Re: Cobaki Estate – Project Approval 08_0200 Mod 2

39A Fencing of Environmentally Sensitive Areas – Precinct 9 and 11 Earthworks

Having regard to the above we request that the attached fencing plan replaces that at Appendix A of the VMP, and that Condition 39A be replaced with the following:

COBAKI ESTATE
OVERALL
Tweed Shire Council
Fencing Plan Precinct 9, 11 and SSP
Drawing No. 331007E-044

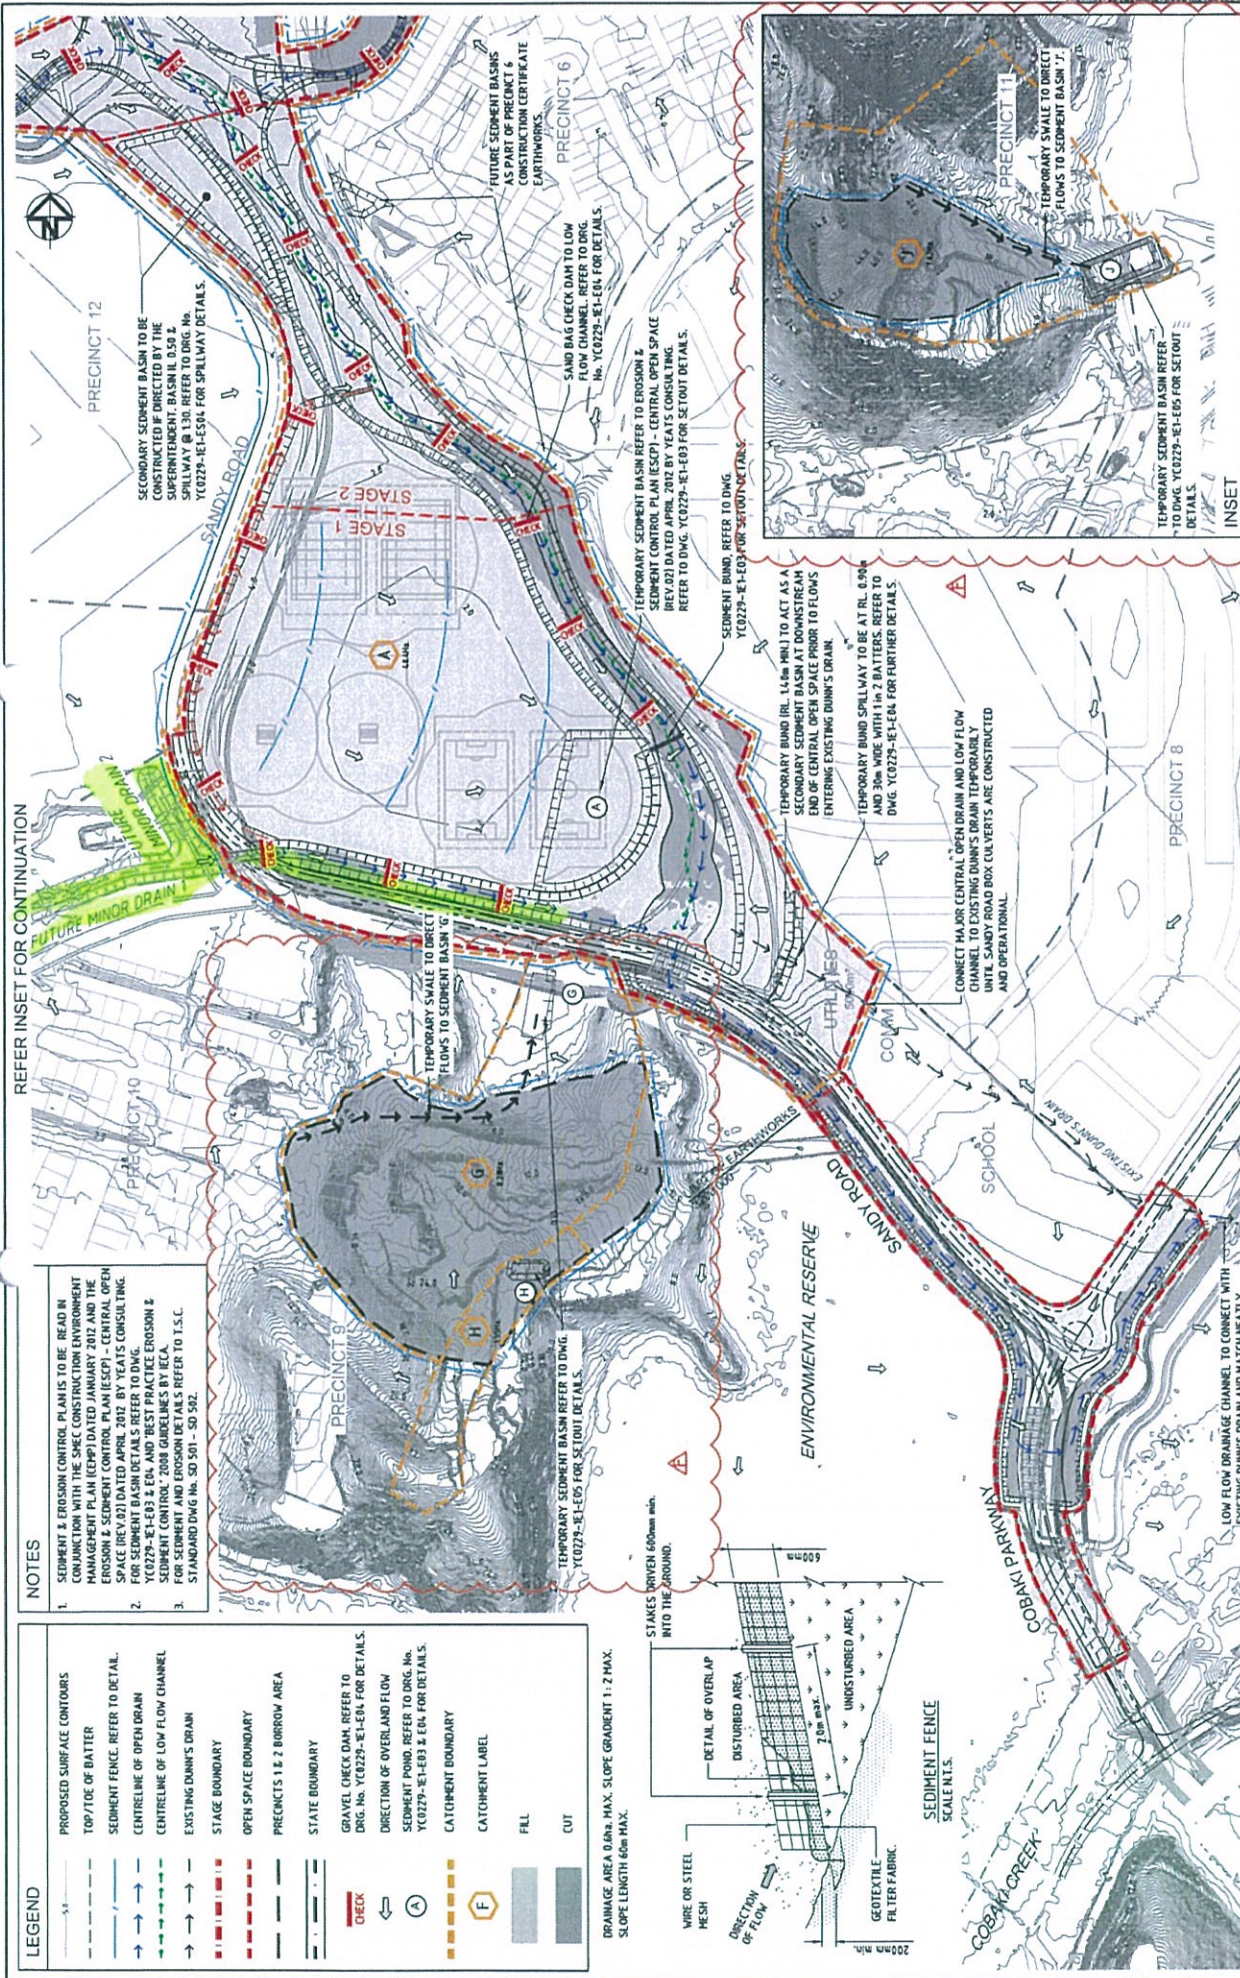
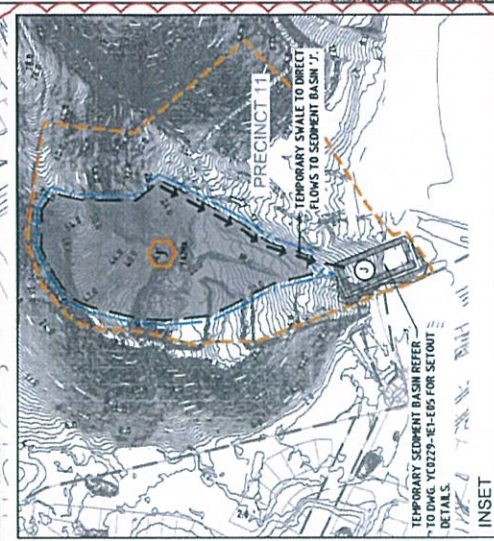
The fencing plan at Appendix A of the VMP does not correctly capture these requirements. We explain why with reference to the attached copy of the plan.

Area 1

- Area 1 is not "environmentally sensitive"
 - The site Revegetation and Regeneration Plan (James Warren & Associates, October 2010) which formed part of the Concept Plan Approval includes
 - figure 9, Condition Assessment, in which the condition of this area is assessed as "very poor".
 - figure 4, Rehabilitation and Management Precincts, which proposes this area for *revegetation*, and
 - figure 5, Endangered Ecological Community Offset Areas, which then proposed the area partly for Freshwater Wetland (within the indicated proposed drain lines) and the balance for Swamp Sclerophyll.

- o It is zoned Private Recreation, not Environmental Protection.
 - o Not only must the existing vegetation within Area 1 be removed prior to revegetation, but along two of its boundaries an extension of Minor Drain 1 approved (and constructed) within the Central Open Space, and the excavation of Minor Drain 2 are intended, each approximately 30m in width.
- It is not adjacent to or connected with the excavations within the approved borrow areas in Precincts 9 and 11 the subject of the Mod in question.

Area 2

Area 2 is to be protected by covenant in order to preserve two old growth trees. However, the area has nothing to do with the works intended under the Mod in question.

Area 3

This area of fencing is not adjacent to, or close to, the borrow pit in Precinct 9 the subject of the Mod.

Areas 4, 5 and 6

These lengths of fencing are not connected with the filling of the *Central Open Space*.

Raptors Nest

The tree containing the raptors nest, which our Environmental Officer had determined was no longer being utilised, is wrongly located in the fencing plan referred to. It was actually located at the edge of the adjacent environment zone, but was felled by a person or persons unknown in December last year.

The boundaries of environmentally sensitive areas in accordance with “Fencing Plan Precinct 9, 11 Borrow Areas Drawing No. 3310071E-044(2)”, together with the 5m buffer to existing threatened flora species within Vegetation Management Areas 7 and 8, shall be surveyed and appropriately marked with either high visibility netting barriers/fencing or permanent fencing during Precinct 9 and 11 earthworks activities.

COBAKI ESTATE
Precinct 9 & 11
Tweed Shire Council
Borrow Areas
Fencing Plan Precinct 9,11 Borrow Areas
Drawing No. 3310071E-044 (2) Rev A

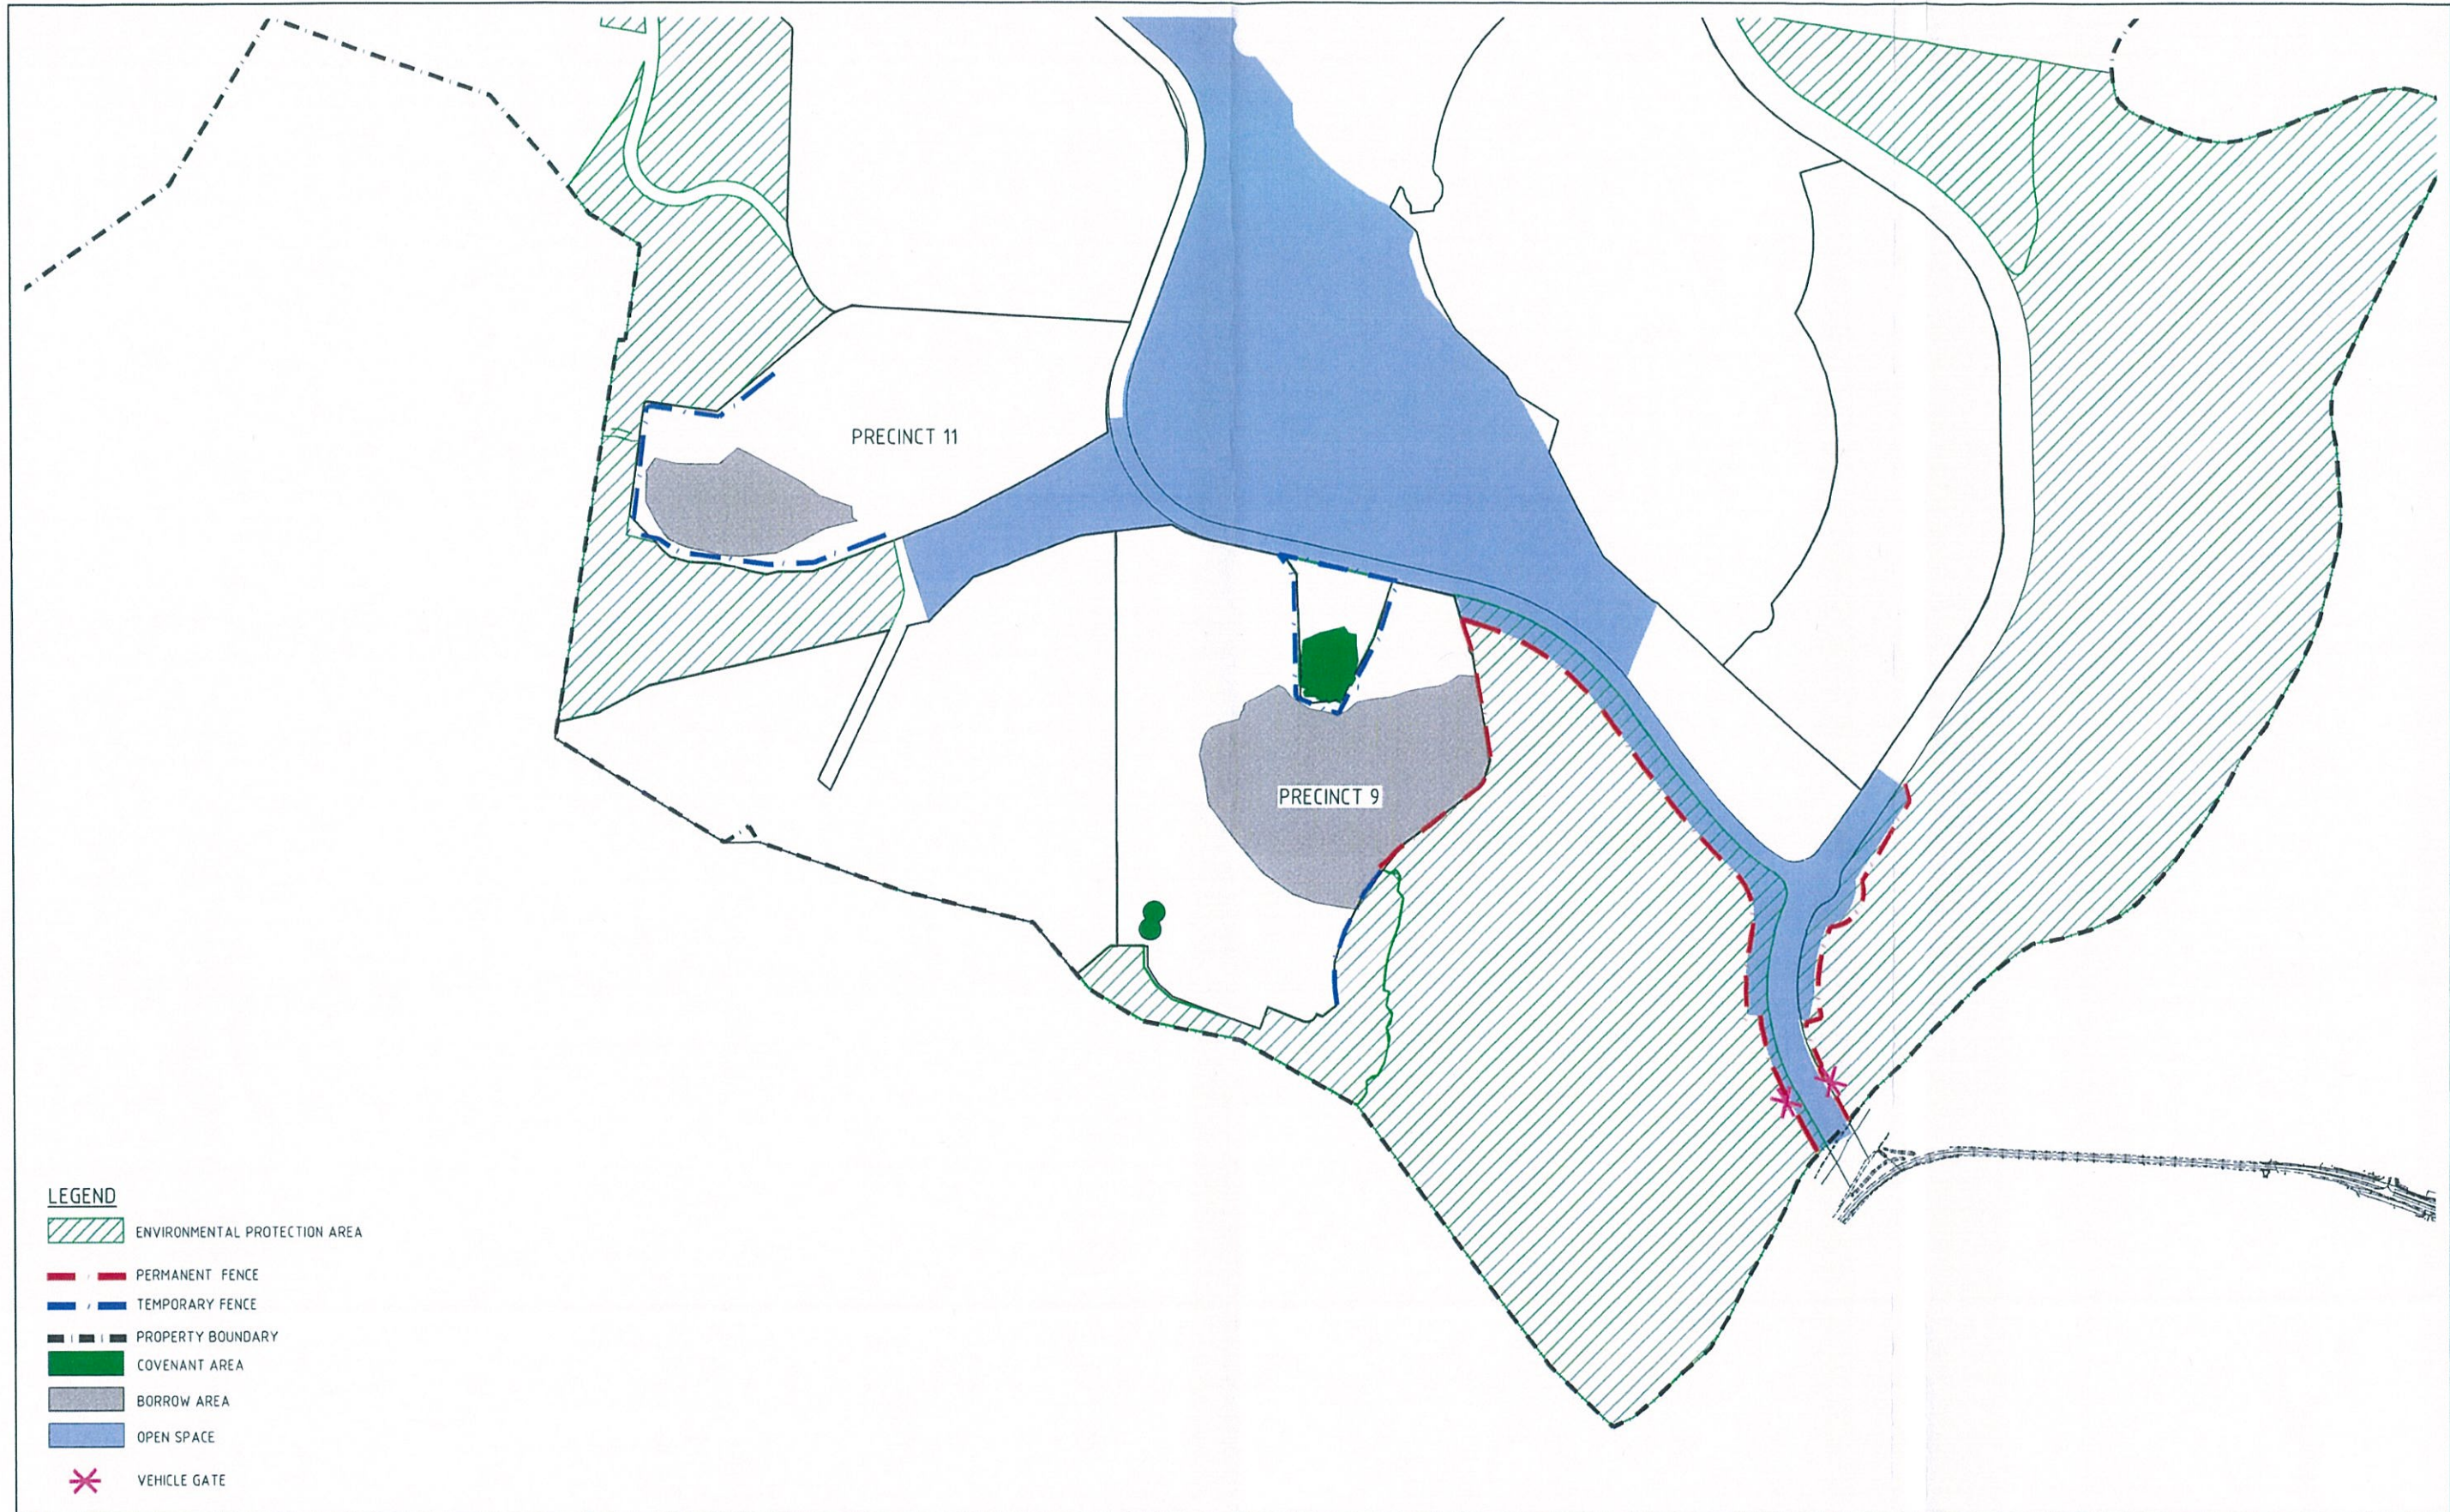
The length of fencing shown in the drawing adjacent to Cobaki Parkway and opposite Precinct 6 is not relevant to any of the earthworks contemplated under the Project Approval of the Central Open Space and its Modifications.

The various revisions of Fencing Plan No 3310071E-044 are derived from an overarching plan of the whole site and have been amended to reflect the specific requirements of the Modifications. The inclusion of the fencing opposite Precinct 6 is an inadvertent inclusion resulting from this process.
